RE: **La Cuentista Subdivision Unit 2**
Request for Pad Certifications– Accepted

- **Lots 2 & 10-12, Block 1;**
- **Lots 1-4, 6-9, 18, Block 4;**
- **Lots 2-8, 17-21, 23, 28 & 29, Block 5;**
- **Lot 7, Block 6**

Grading Plan Stamp Date: 11/16/17
Certification Dated: 2/11/19
Hydrology File: D10D002B

DRAINAGE AND TRANSPORTATION INFORMATION SHEET (REV 6/2018)

CITY OF ALBUQUERQUE PUBLIC WORKS DEPARTMENT ENGINEERING GROUP			
LA CUENTISTA SUBDIVISION UNIT II GRADING PLAN			
Design Review Committee	City Engineer Approval	Mo./Day/Yr.	Mo./Day/Yr.
City Project No. 709787 709788		Zone Map No. C-10, C-11	Drawing 2 OF 510 OF 32

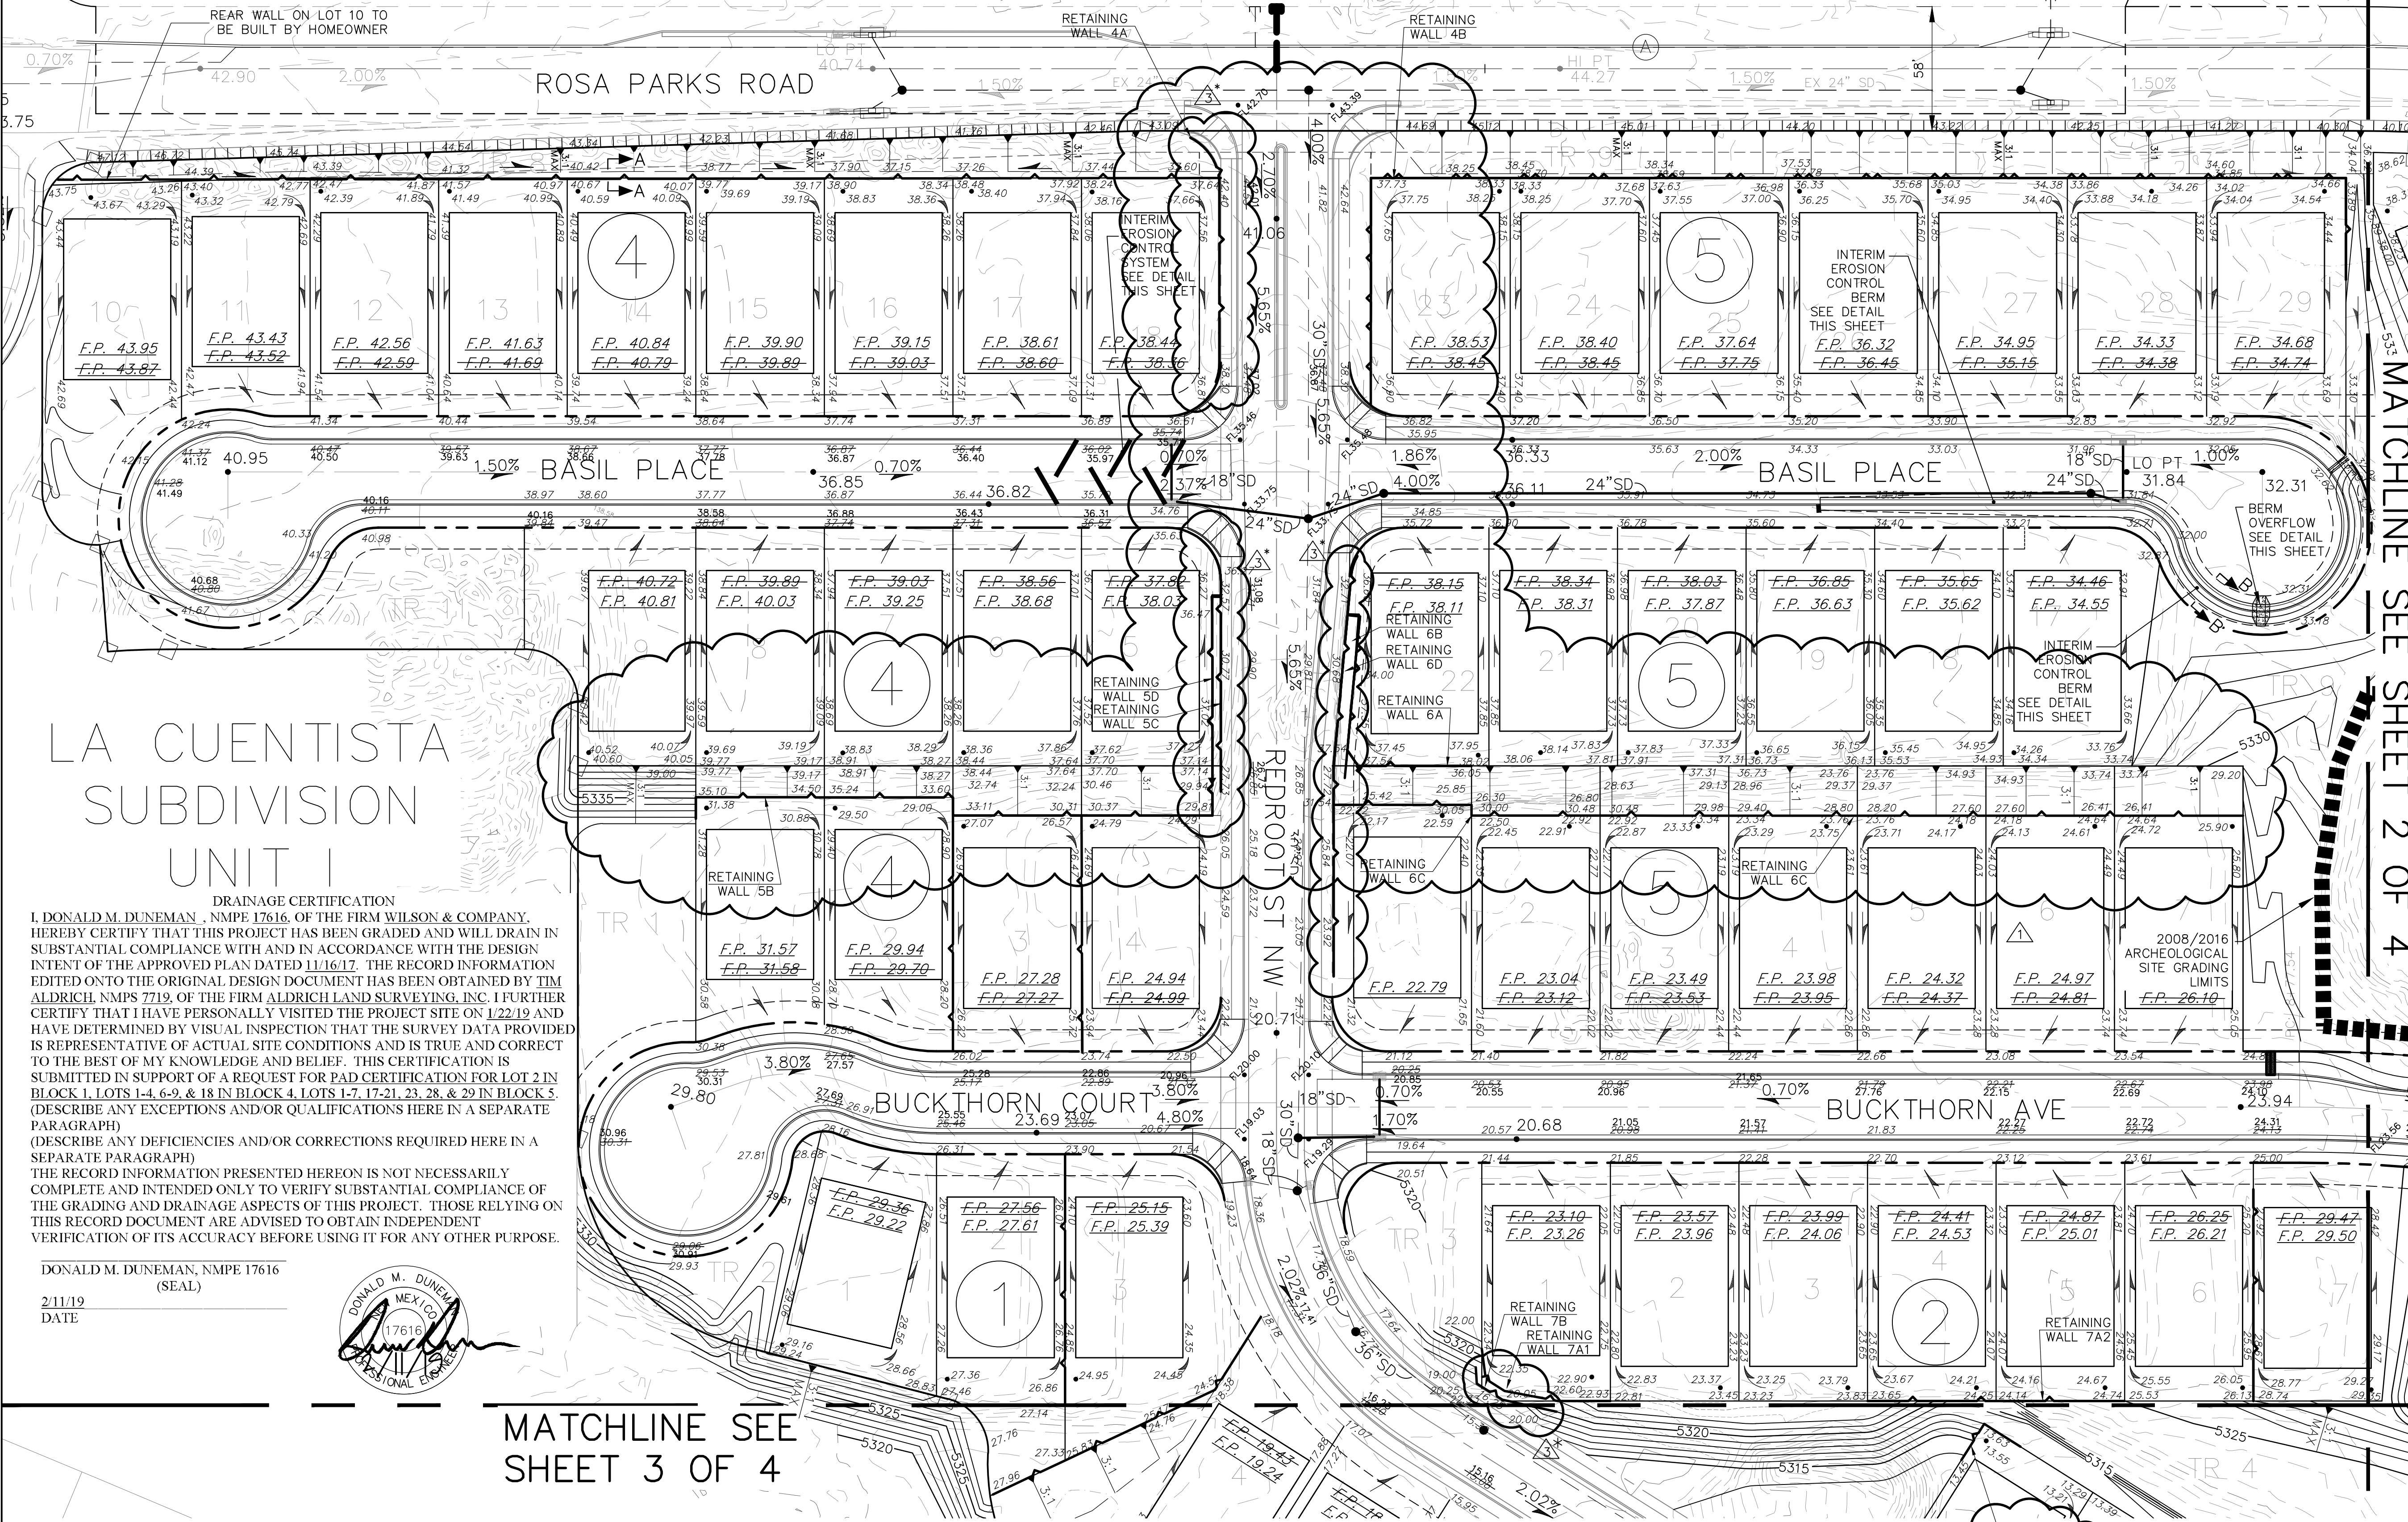
Prior to Pad Certification for Lot 1, Block 5, the retaining wall between Lot 1 and Redroot St must be constructed.

CITY OF ALBUQUERQUE PUBLIC WORKS DEPARTMENT ENGINEERING GROUP			
LA CUMENTISTA SUBDIVISION UNIT II GRADING PLAN			
Design Review Committee	City Engineer Approval	Last Design Update	Mo./Day/Yr.
City Project No. 709787 709788	Zone Map No. C-10, C-11	Drawing 4 OF 5	Sheet 12 OF 32

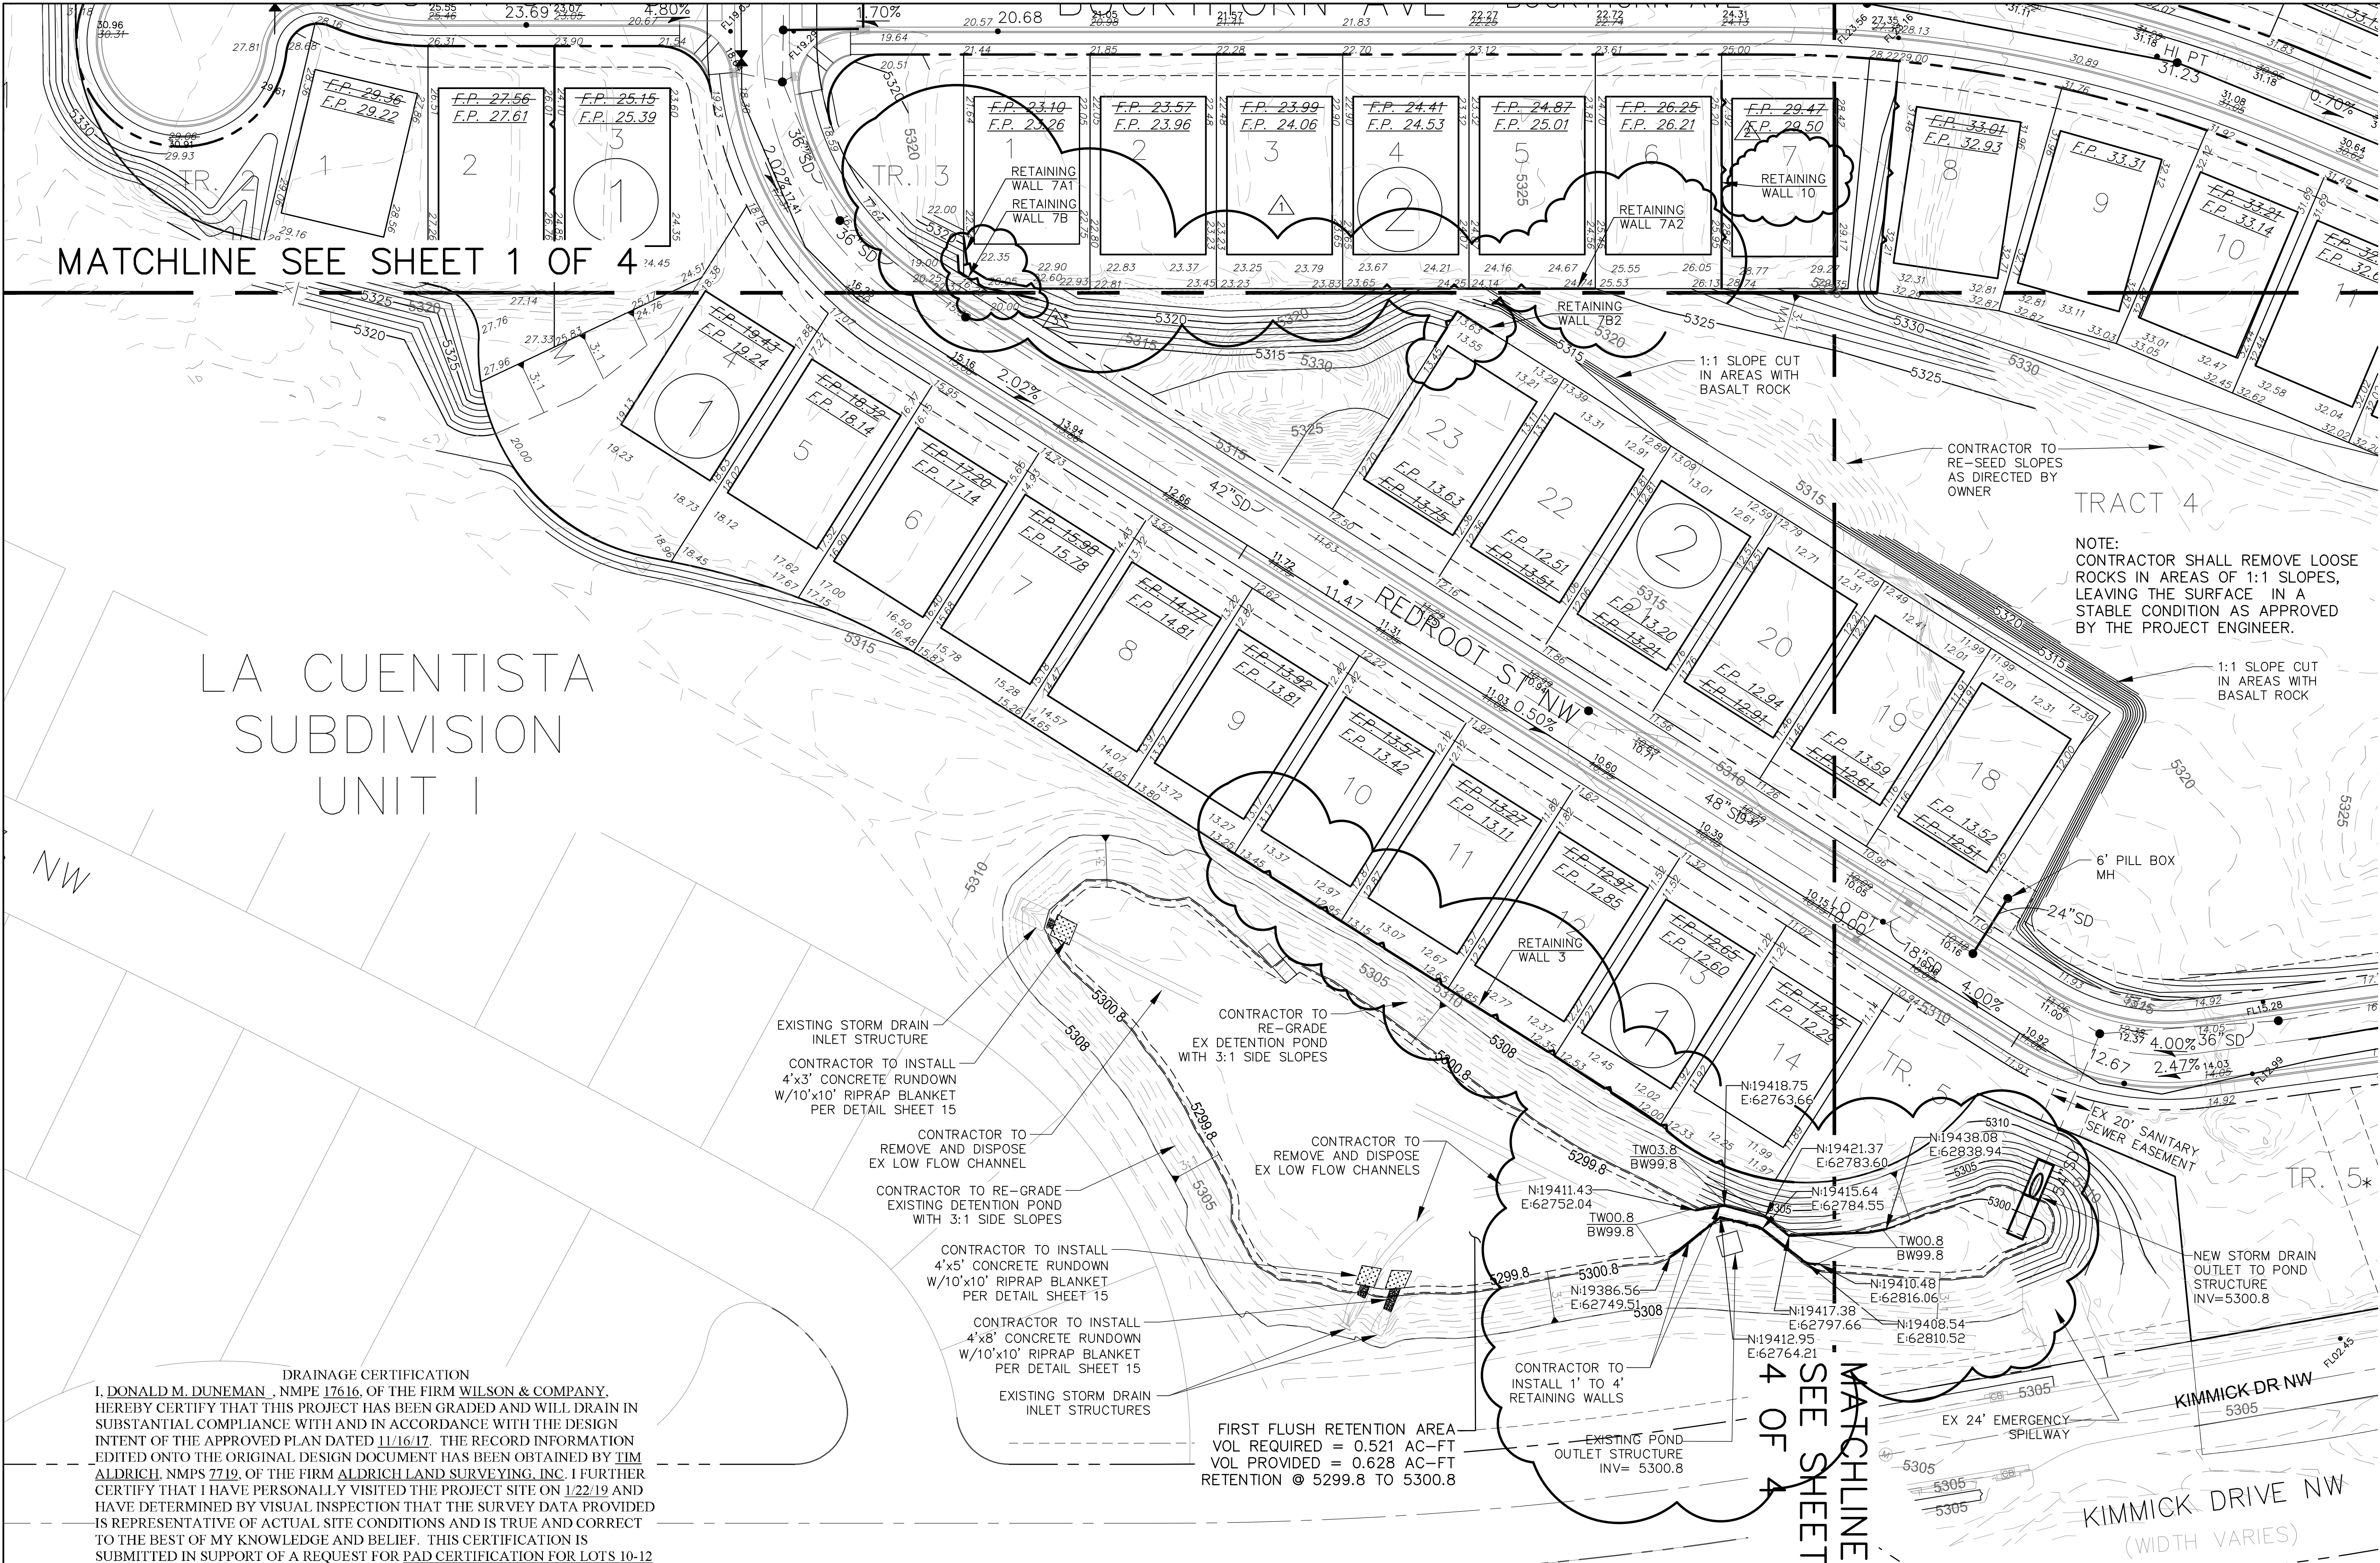
WALL 7B
ENCROACHES CITY
ROW AND REQUIRES
A REVOCABLE
PERMIT, ETC. SAME
AS PREVIOUS.NO
WALL CONSTRUCTION,
INCLUDING FOOTERS,
IS PERMITTED IN
THE ROW WITHOUT
AN ENCROACHMENT
AGREEMENT.
